Re: Permanente Quarry, Mine ID # 91-43-0004
Application for Reclamation Plan Amendment (PLN 19-0106)
Response to July 22, 2019 Incompleteness Determination

Reference: Responses to SCC Incompleteness Determination for Permanente Quarry

Reference: Permanente Quarry – WMSA Slope Instability Remediation Plan

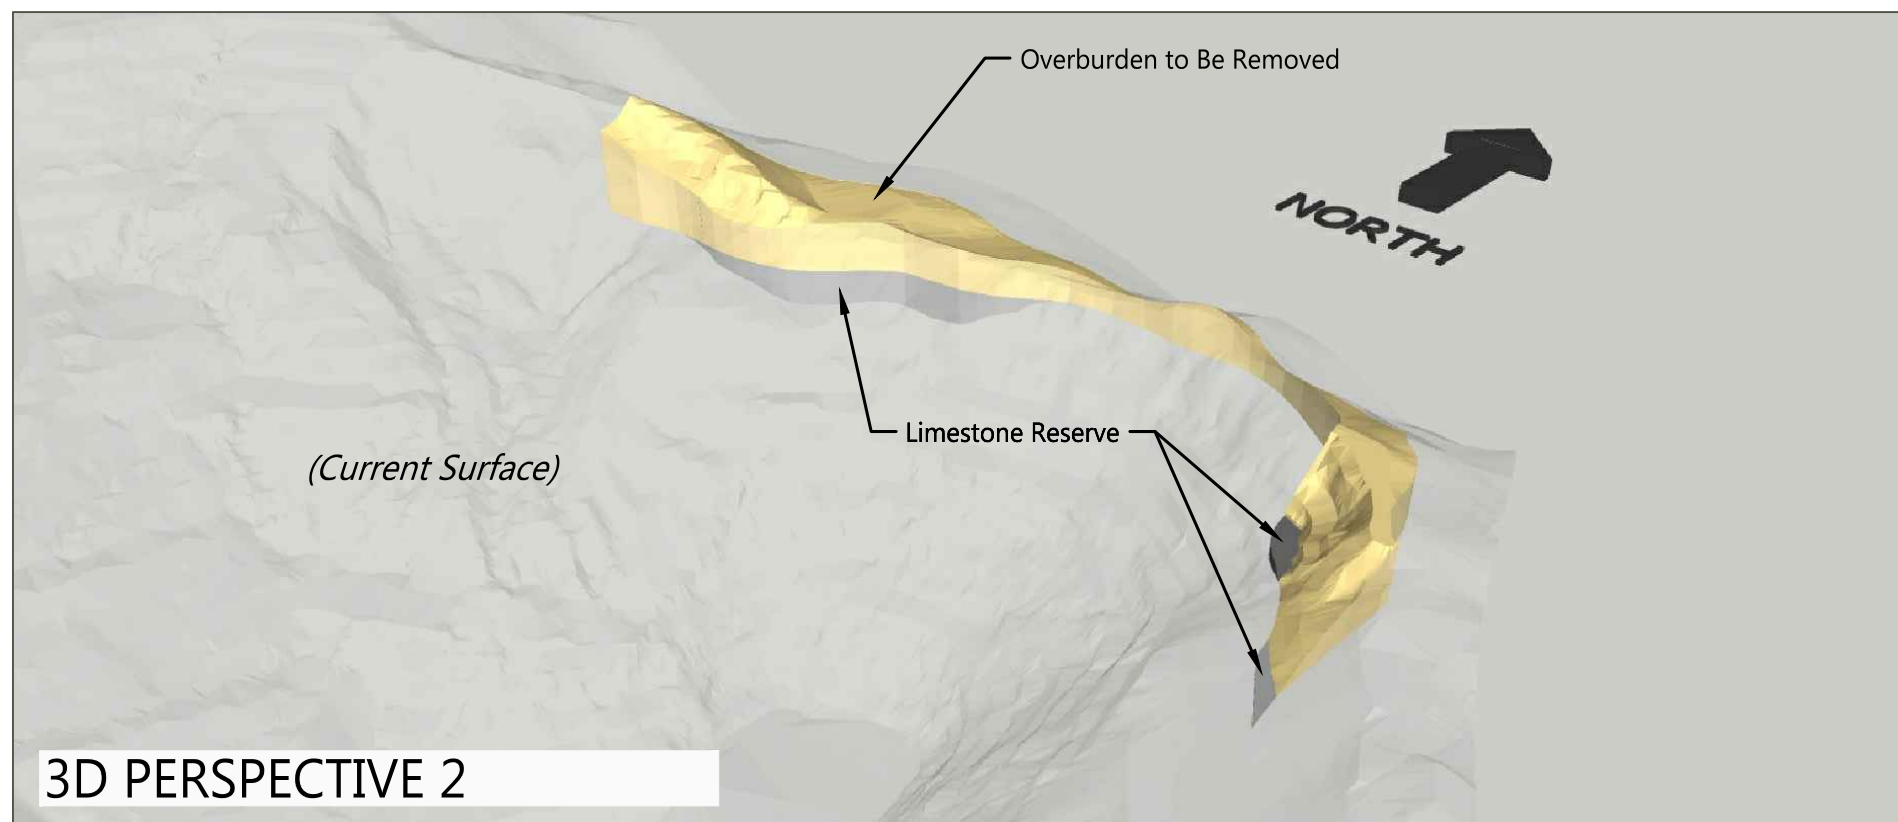
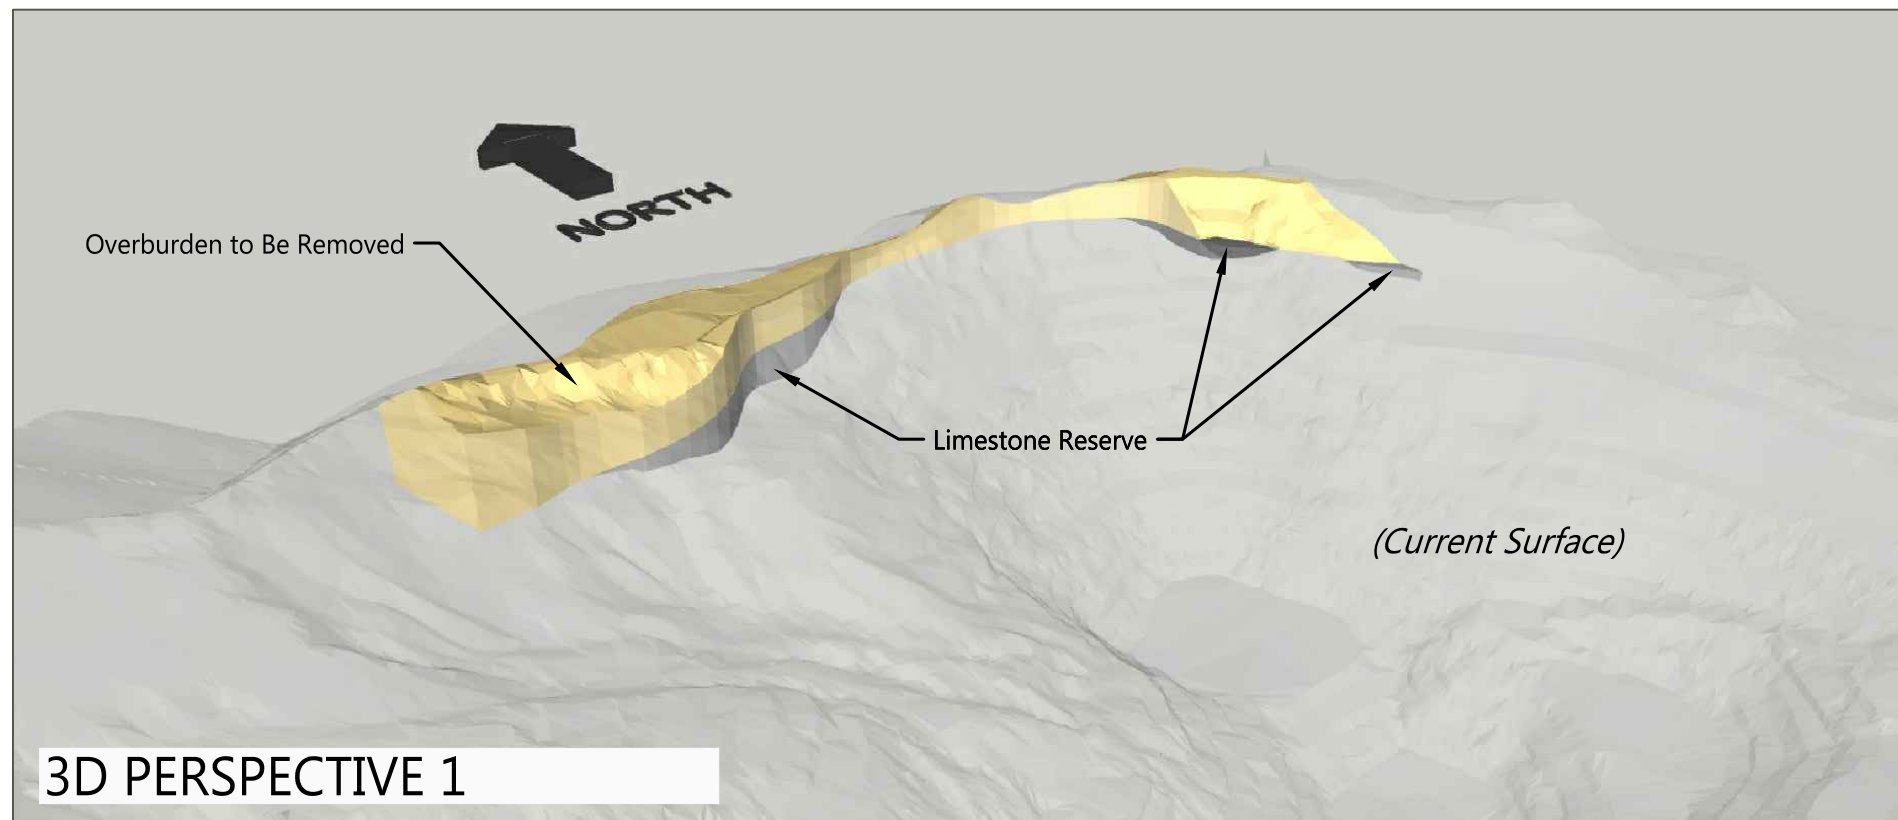
- A. ***Diagram showing extent of proposed mining within the 1972 Ridgeline Protection Easement.*** ...Please submit a diagram or diagrams which clearly shows the limits of the 1972 Easement, including the areas within the 1972 Easement where mining activities are forbidden, and the extent of proposed mining activities within or in close proximity to those areas.

Thus, while we appreciate that the County may find additional diagrams to be helpful, the County's comment does not raise any question of incompleteness. Nonetheless, Lehigh will submit additional diagrams as requested. **Attachment 1** to this letter includes additional figures, cross-sections and simulations that show the location of the 1972 easement and where mining and regrading would occur in proximity to the easement.

Reclamation Plan

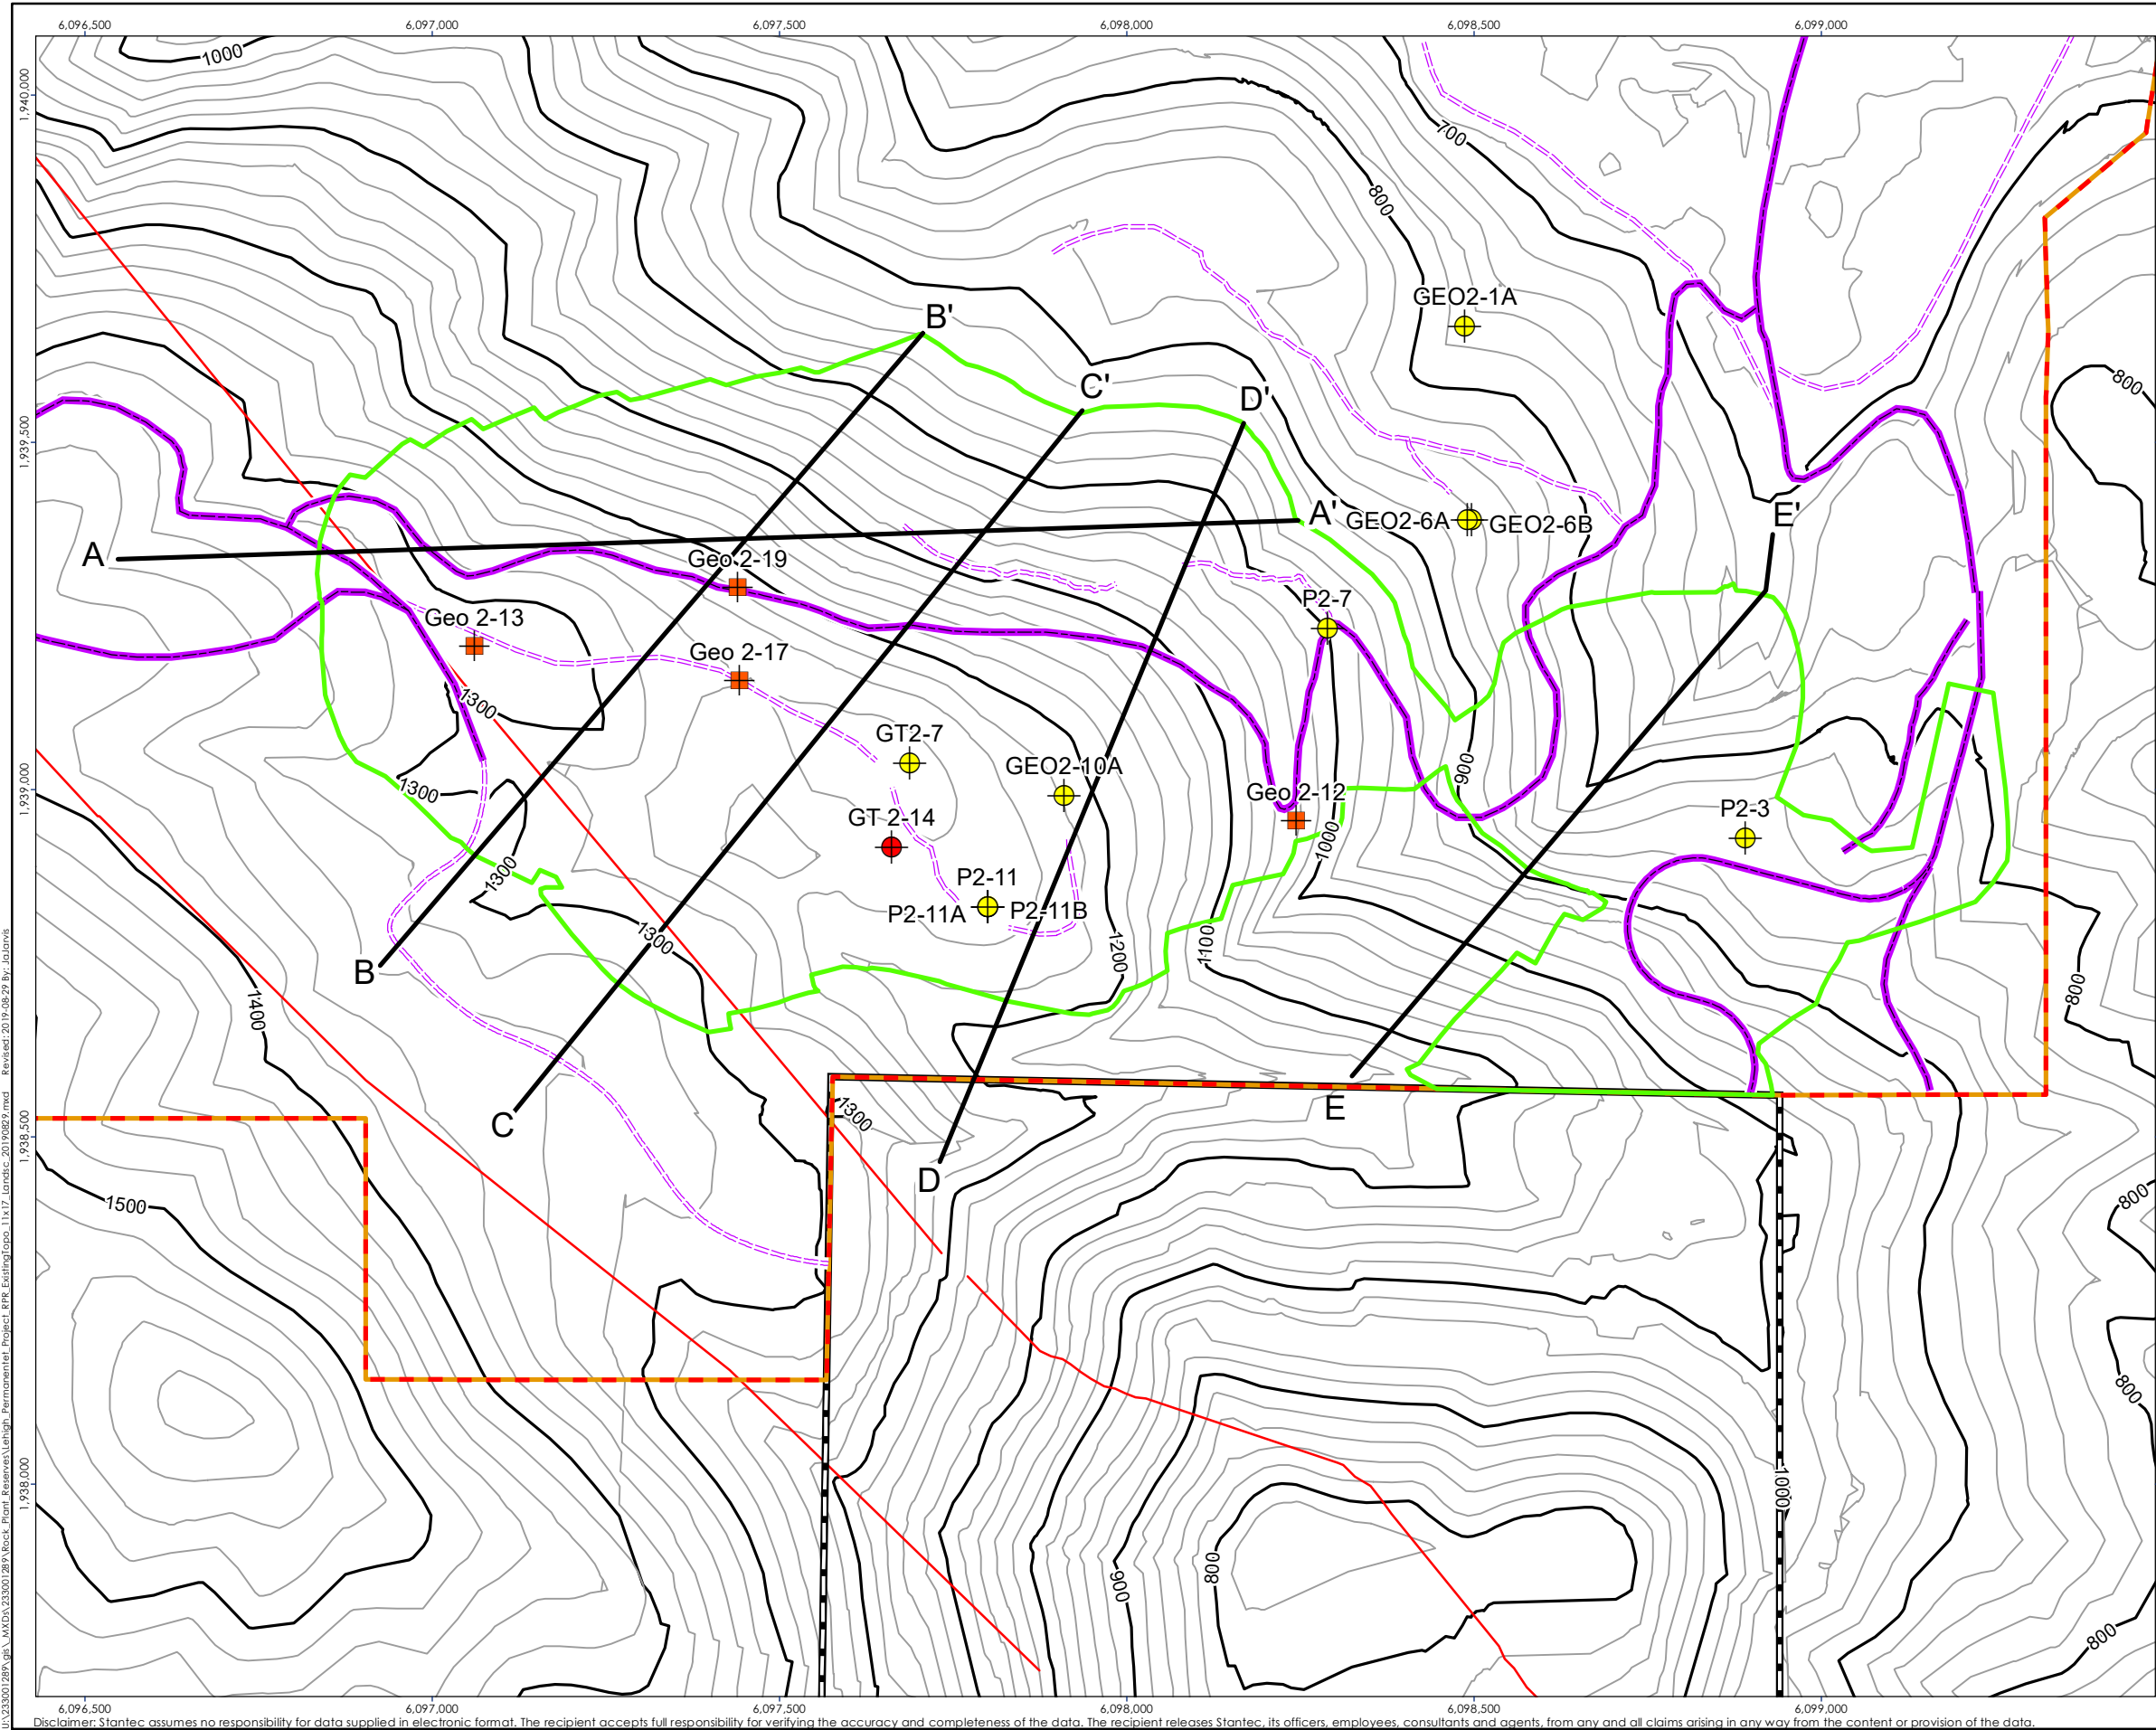
C. *Rock Plant Reserve Area Mining and Access Design.* ...Please provide an overview of [the Rock Plant Reserve area] on one sheet at a scale sufficient to show details, and include a separate sheet showing how this area will be accessed, along with details showing how this area and the access road will be reclaimed.

- Figure 2-2 Mine Plan
- Figure 3-1 Reclamation Plan
- Rock Plant Reserve Figure 3.1 has been revised to include the utility road alignment and new cross-section E.
- Rock Plant Reserve Figure 3.2 is a new figure that presents the access to the quarry area.
- Rock Plant Reserve Figure 3.3 (previously Figure 3.2) has been revised to include the utility road alignment and new cross-section E.
- Rock Plant Reserve Figure 3.4 (previously Figure 3.3) shows the cross-sections including E-E'.
